ISO/IEC/ IEEE 8802-3

AMENDMENT 8
2021-10

AMENDMENT 8: Physical layer specifications and management parameters for 2.5 Gb/s, 5 Gb/s, and 10 Gb/s automotive electrical ethernet

Amendment 8:
Physical Layer Specifications and Management Parameters for 2.5 Gb/s, 5 Gb/s, and 10 Gb/s Automotive Electrical Ethernet

Figure 44–1—Architectural positioning of 10 Gigabit Ethernet

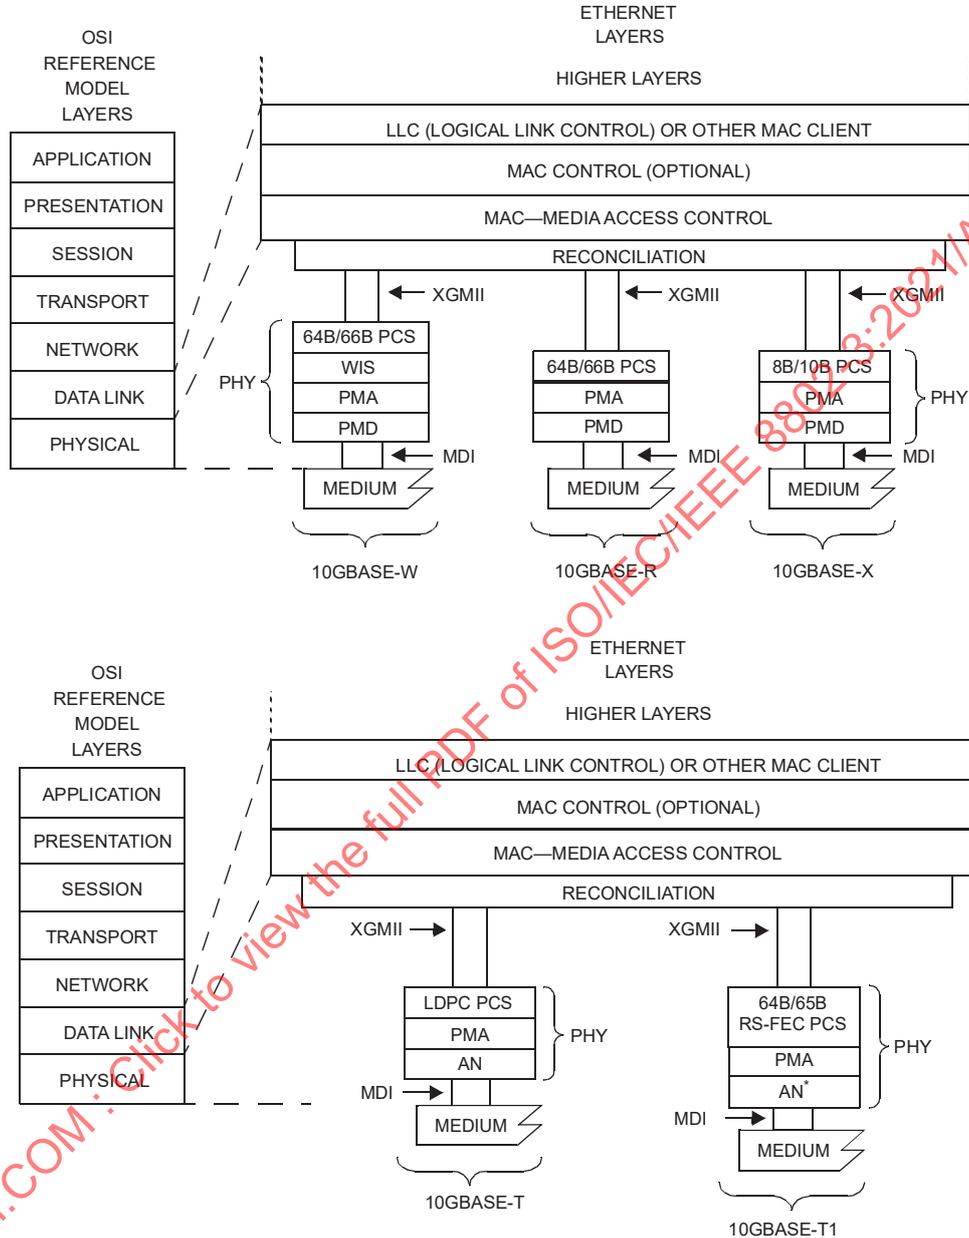
Replace Figure 44-1 with the following figure, which adds 10GBASE-T1:

Figure 125–1—Architectural positioning of 2.5 Gigabit and 5 Gigabit Ethernet

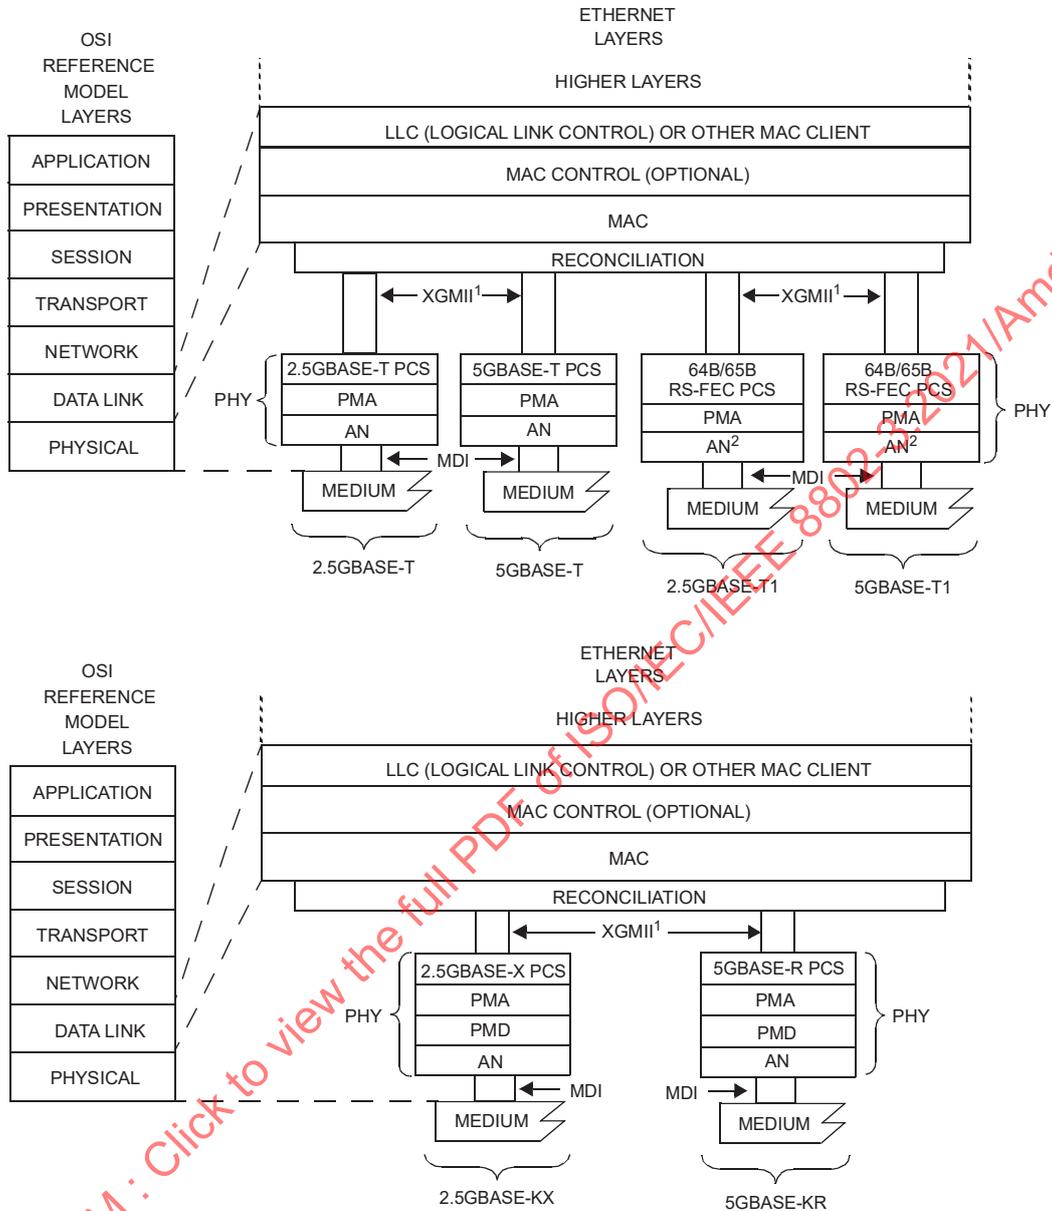
Replace Figure 125–1 (as modified by IEEE Std 802.3cb-2018) with the following figure, which adds 2.5GBASE-T1 and 5GBASE-T1.
